King Street Pump Station Improvements (Volume I) & ASR Lime System Improvements (Volume II) - RFCSP
Solicitation Number: CO-00670
Job No.: 20-6002 and 22-8603

ADDENDUM 2
October 12, 2023

10/6/2023 11:55:59 AM C:\Users\stevie.guard\Documents\09308-D-HSPS_BLDG-2021_stevie.guard.rvt

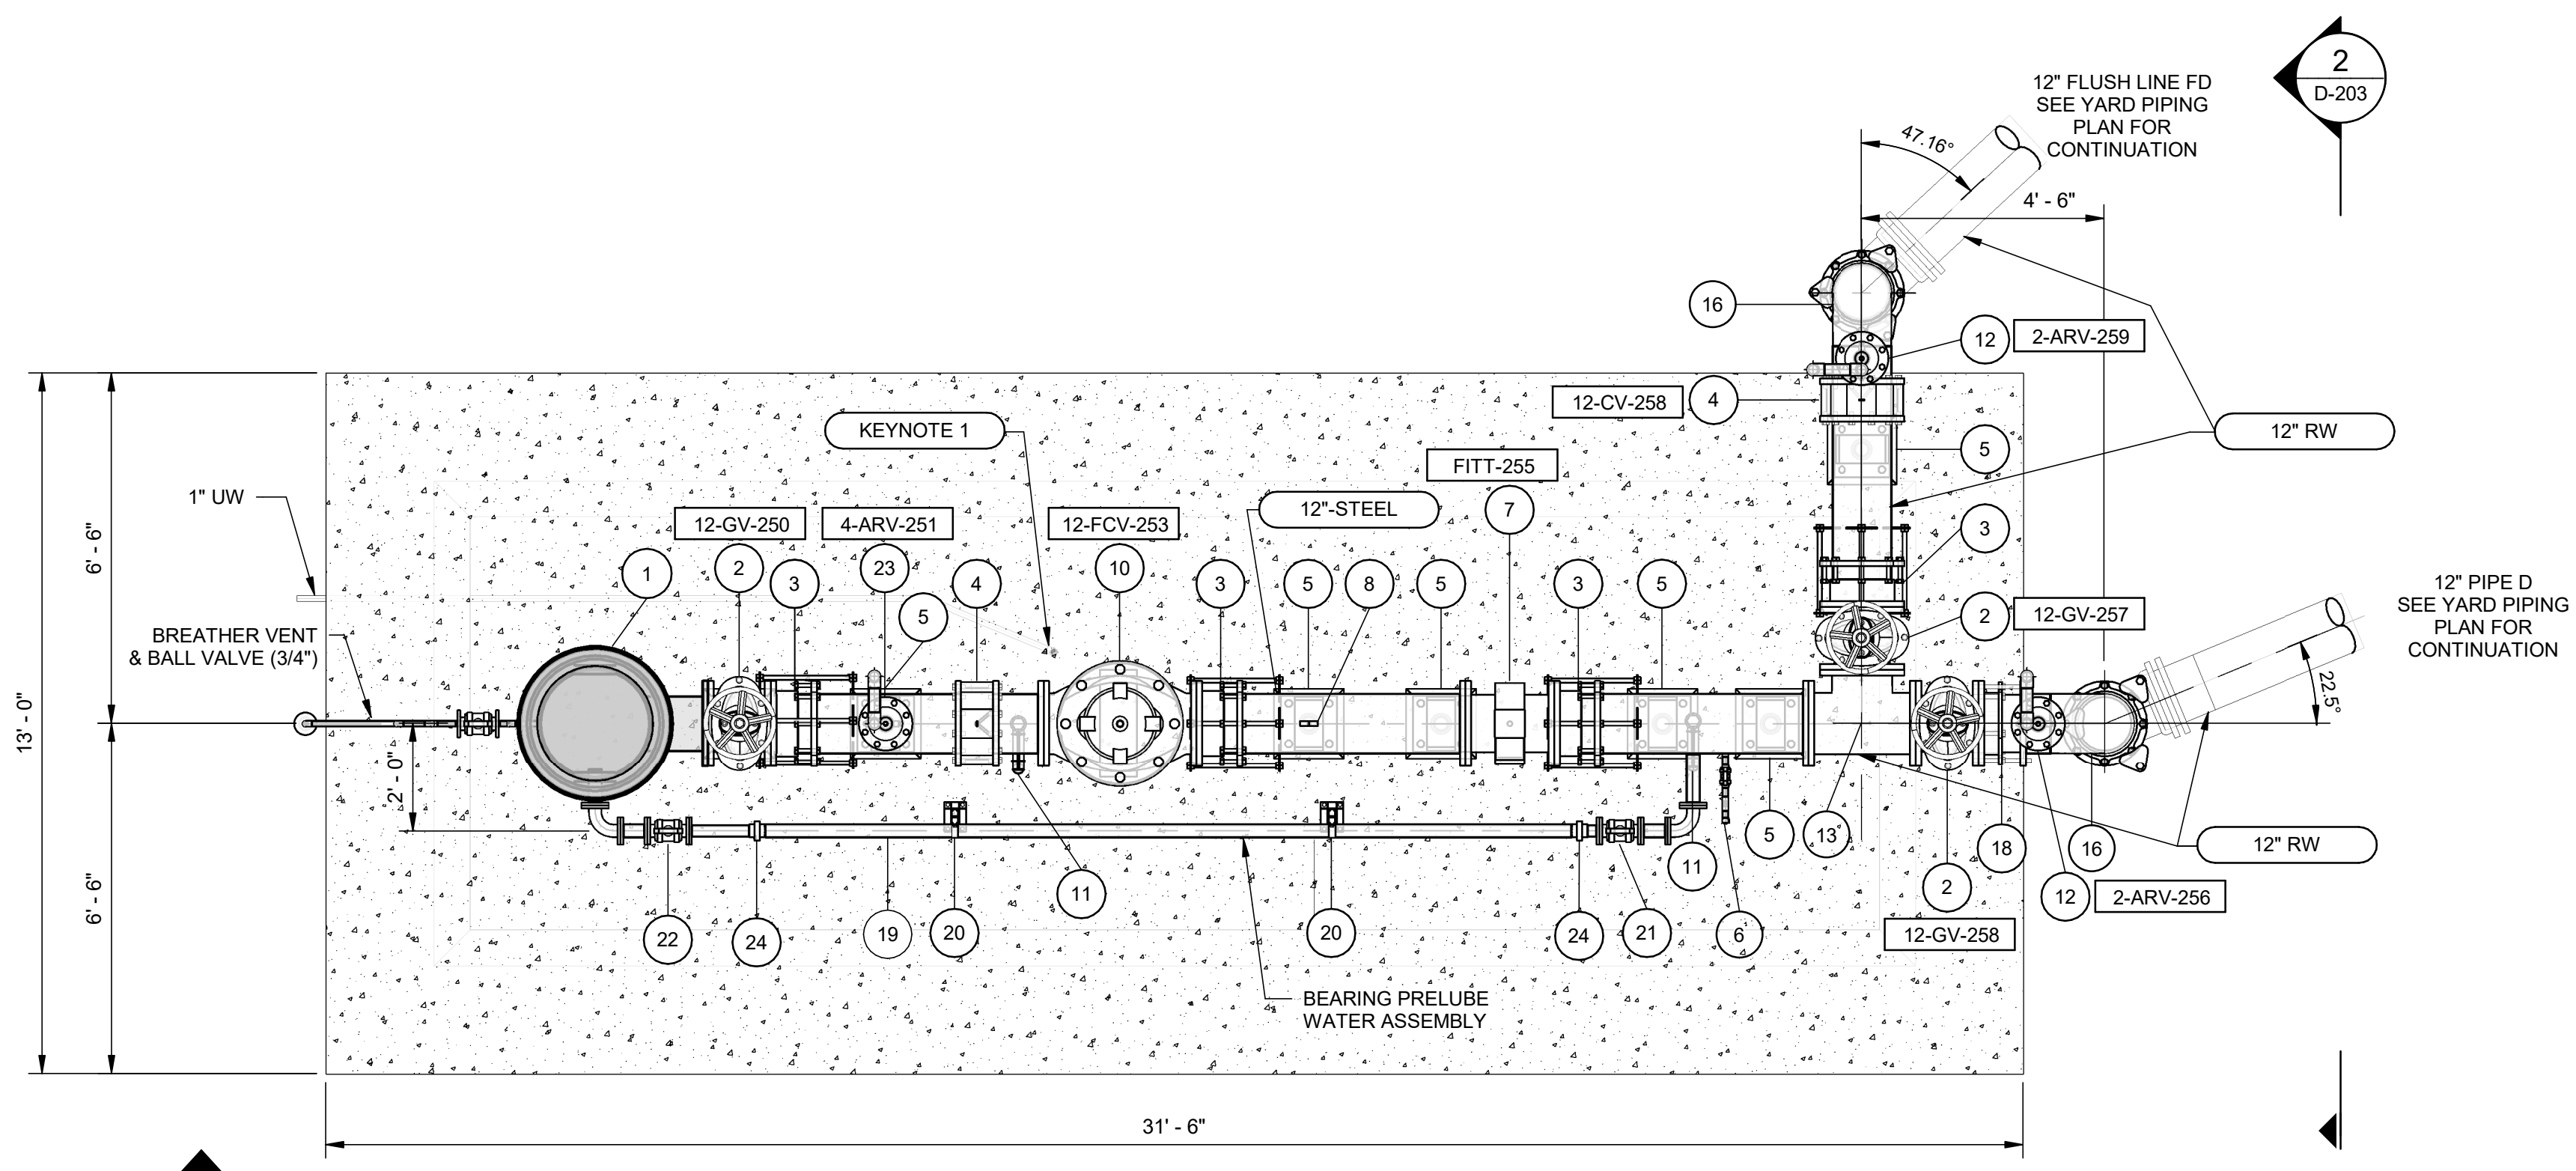
- 49. Question: Contract Drawings, Sheet D-203/204, add permanent pipe support under 12" gate valve that completely supports weight. Pump discharge should not be anchor point for any of discharge piping.**

Response: Refer to "Changes to the Plans" section item No. 3, item No. 4, item No. 5, and item No. 6 in this addendum. Pipe support added to drawings.
- 50. Question: Contract Drawings, Sheet D-203/204, add housekeeping pad/foundation around well casing pipe extended above finish floor. Surface plate assembly will be welded to well casing after installation/leveling. Grout to be poured up to bottom surface of top plate of the surface plate assembly.**
